Quiet Use Coalition comments on the Leadville and Salida Ranger District Dispersed Camping Management Preliminary EA

Please accept and fully consider the following comments on behalf of the Quiet Use Coalition (QUC) on the Leadville and Salida Ranger District Dispersed Camping Management Preliminary EA.

Image 4 enhanced aerial aerial image

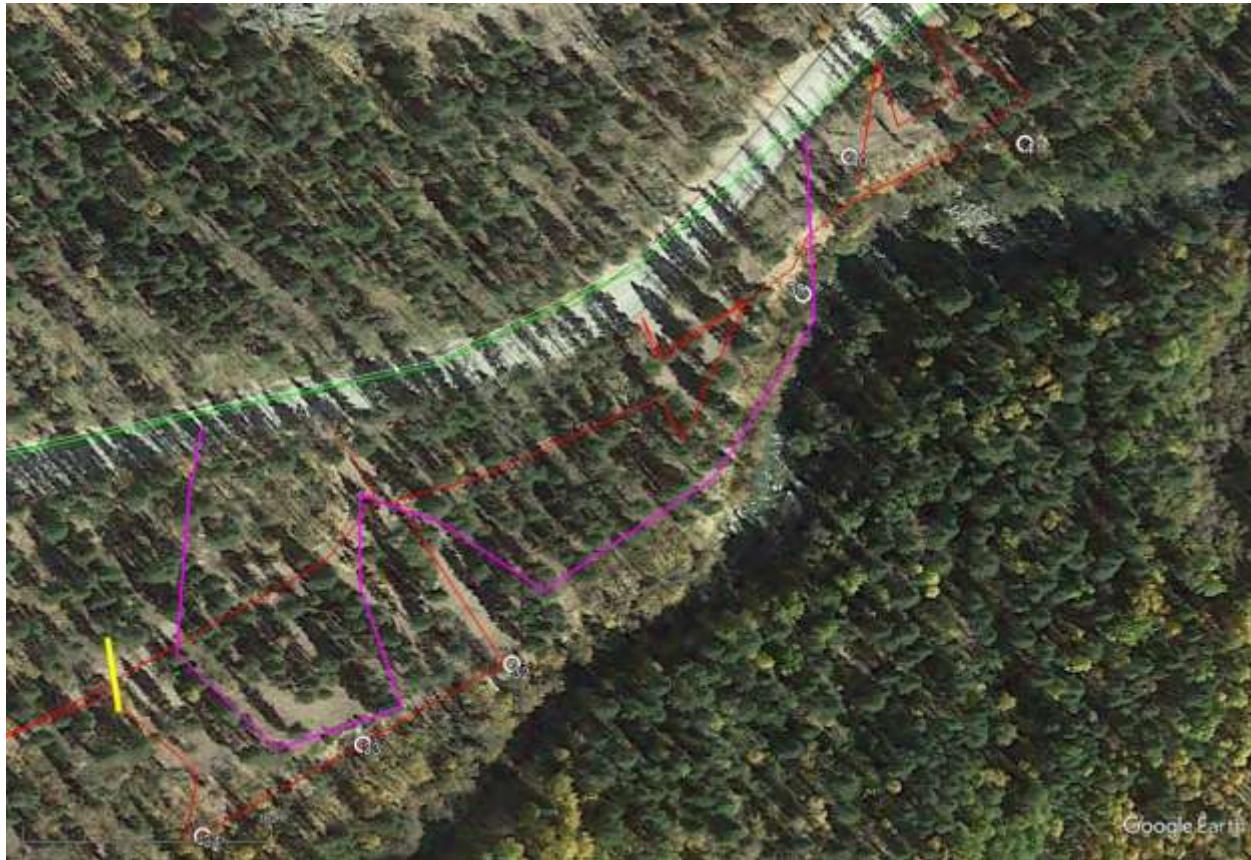
We have included Image 4 below that better depicts the extent and location of existing unauthorized motorized routes.

QUC has few concerns with the designation of this route. There are actually four existing access routes between Road 390 and unauthorized routes used for camping. Only two should be designated as open and steps should be taken to deter not camping related recreational motor vehicle loop/pass through in a designated camping area.

There may be some concerns with designating a road in a 9A Management Area.

Note that QUC installed a buck and pole fence and steel post with steel "no vehicles beyond this point" sign with USFS approval in 2022. That closure should remain and there should be no connection available to routes to the west.

Image 6 enhanced aerial image of Sugarloaf area

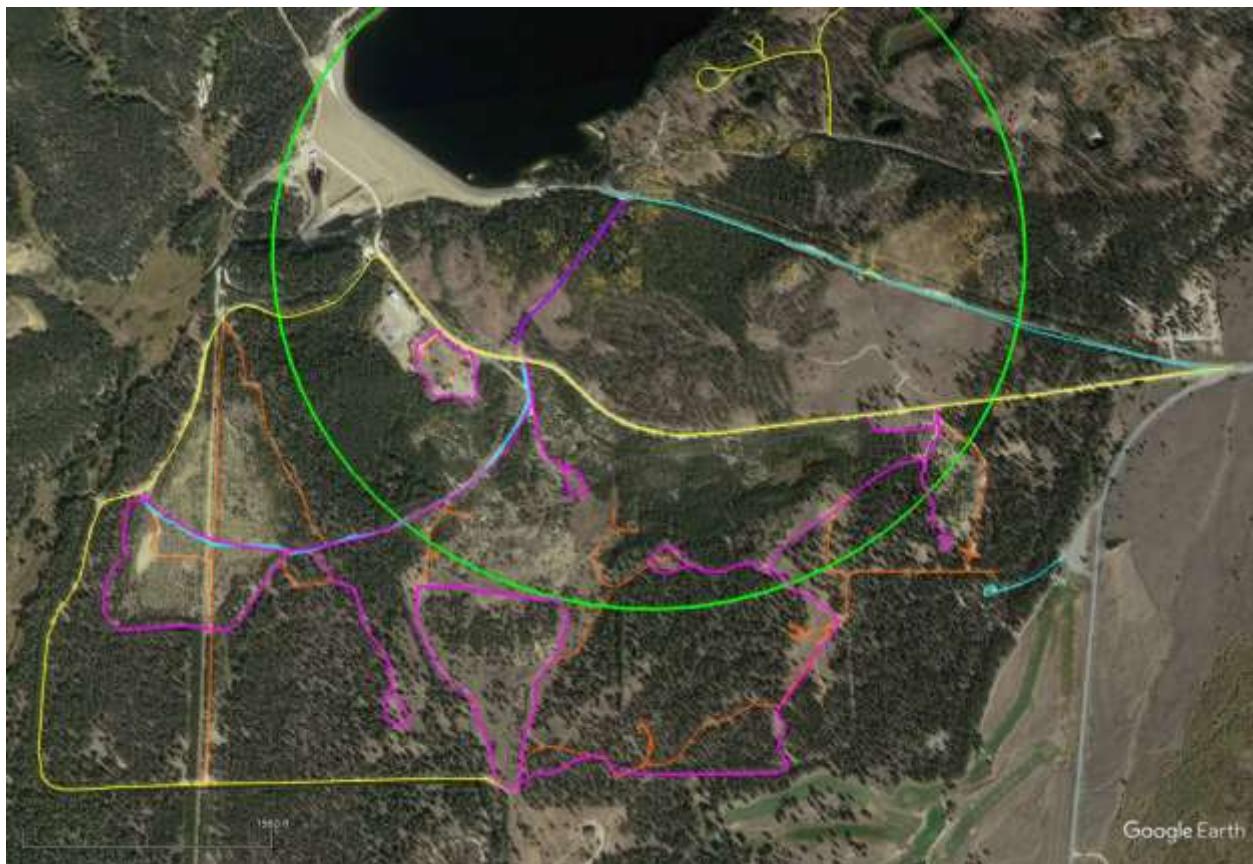
New Roads and dispersed campsites must not be designated within one half mile of the known active Northern Goshawk nest between County Road 4 and Forest Road 113.

CPW recommended buffer zones and seasonal restrictions for Northern Goshawk nests specify no surface occupancy within one half mile of active nests, and no human encroachment within one half mile of the nest from March 15 through September 15.⁴

We oppose the prosed designation of new roads TL 3, 4 and 12b in this area, and the designation of campsites off these roads as these will create new legally open surface occupancy and encourage human encroachment within one half mile of this Northern Goshawk nest.

We oppose attempts to designate campsites in this area that are open before March 15 and after September 15. It will be difficult to achieve compliance with the seasonal closure of those sites as it would require the installation, monitoring and enforcement of locked gates and signage. There are other dispersed campsites available in this area during that time period. The designation of new roads, campsites and routes to those campsites would be undesirable surface occupancy.

As a compromise will can accept the designation of 11, 12 and 12a as these are further away from the nest, adjacent to designated road 113, and are connector routes. The USFS must avoid designating new campsites that stray too far to the west and north from these roads to minimize impacts on this nest.

Note that TL 6 is claimed by Lake County to be part of a loop formed by Lake County Road 48 so it likely will have to remain open. The USFS must avoid designating any dispersed campsites along that road within one half mile of the nest.
